Subject: Amendment No. 2 to Facility Operating License No. NPF-22 -
Susquehanna Steam Electric Station, Unit 2

SUSQUEHANNA STEAM ELECTRIC STATION, UNIT 2

AMENDMENT TO FACILITY OPERATING LICENSE

Amendment No. 2
License No. NPF-22

Figure 3.4.11-1
THERMAL POWER LIMITATIONS

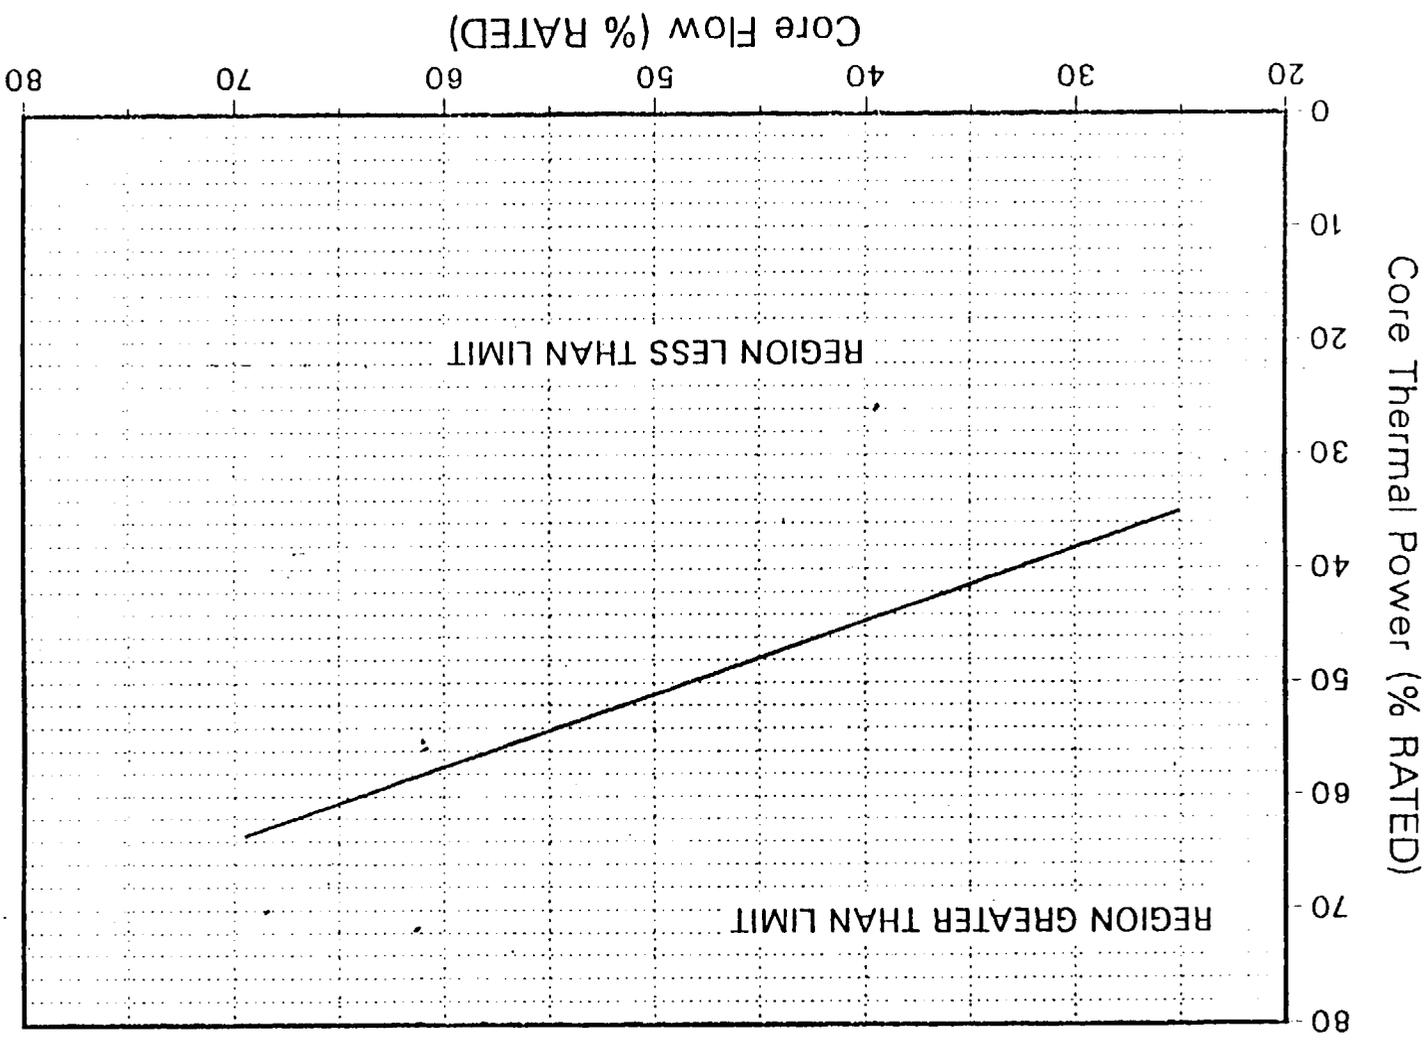
- 3.4.1.1 Two reactor coolant system recirculation loops shall be in operation. and:
- a. Total core flow shall be greater than or equal to 45 million lbs/hr, or
 - b. THERMAL POWER shall be less than or equal to the limit specified in Figure 3.4.1.1-1.

- a. With one reactor coolant system recirculation loop not in operation, immediately initiate an orderly reduction of THERMAL POWER to less than or equal to the limit specified in Figure 3.4.1.1-1, and be in at least HOT SHUTDOWN within the next 12 hours.

- b. With no reactor coolant system recirculation loops in operation, immediately initiate an orderly reduction of THERMAL POWER to less than or equal to the limit specified in Figure 3.4.1.1-1, and initiate measures to place the unit in at least STARTUP within 6 hours and in HOT SHUTDOWN within the next 6 hours.

- c. With two reactor coolant system recirculation loops in operation and total core flow less than 45 million lbs/hr and THERMAL POWER greater than the limit specified in Figure 3.4.1.1-1:

1. Reduce THERMAL POWER to less than or equal to the limit specified in Figure 3.4.1.1-1, or
 2. Increase core flow to greater than 45 million lbs/hr, or

- b) If the APRM or LPRM*** neutron flux noise levels are greater than or equal to three times their established baseline levels, immediately initiate corrective action and restore the noise levels to within the required limits within 2 hours by increasing core flow to greater than 45 million lbs/hr. and/or by initiating an orderly reduction of THERMAL POWER to less than or equal to the limit specified in Figure 3.4.1.1-1.

1. When operating with one or no recirculation loops, the plant will immediately initiate an orderly reduction in thermal power to less than a specified limit.
2. When in twin loop operation at flow rates less than 45 million lb/hr, reduce thermal power to the specified limit or monitor APRM and LPRM neutron flux levels at least once per 8 hours and insure that they are less than three times their established baseline levels.

The staff has reviewed these proposed changes and has found that they are prudent and acceptably resolve our Thermal-Hydraulic Stability concerns for Susquehanna Units 1 and 2, assuming long term single loop operation is not permitted. Should such operation be requested in the future the staff will reevaluate this Technical Specification to determine if additional modifications are required.
